ST/SG/AC.10/C.3/2008/13
9 April 2008

**MISCELLANEOUS PROPOSALS OF AMENDMENTS TO THE MODEL REGULATIONS
ON THE TRANSPORT OF DANGEROUS GOODS**

4.1.4.1, Packing Instruction P200 (4), Special packing provisions “k”

Transmitted by the European Industrial Gases Association (EIGA)*

Fig. 1 Example of an externally threaded cylinder connection

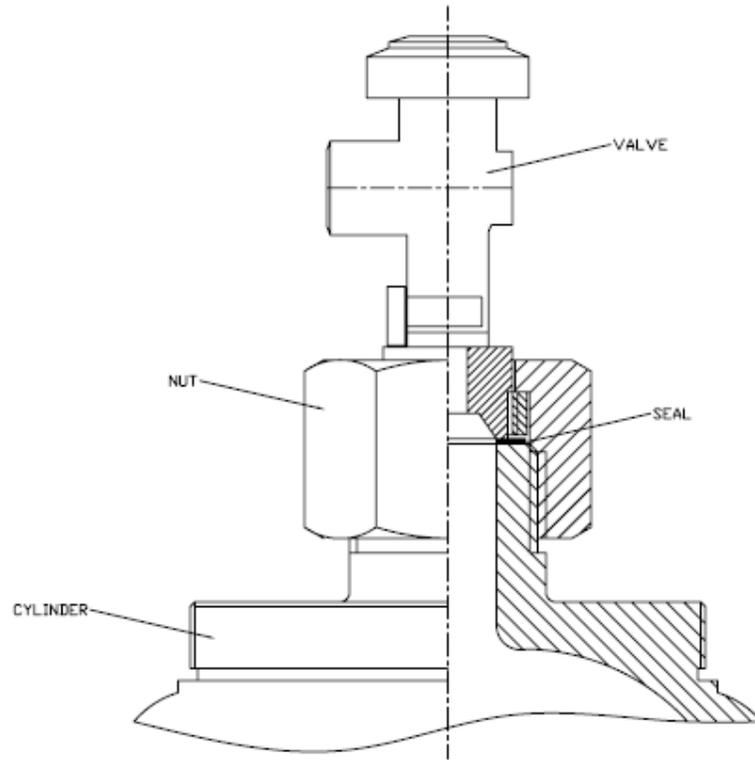
5. A typical valve to cylinder connection system is shown below in Fig 1, and consists of an externally threaded cylinder and special nut and cylinder valve.

6. The proposal is to modify Packing Instruction P200 item (4) Special packing provisions “k”, paragraph 7 such that cylinder/valve combinations in accordance with ISO 10692-2 may be permitted.

7. The proposed sentence will read as follows:

“Each valve shall be capable of withstanding the test pressure of the pressure receptacle and be connected directly to the pressure receptacle by either a taper thread or other means which meets the requirements of ISO 10692-2:2001.”
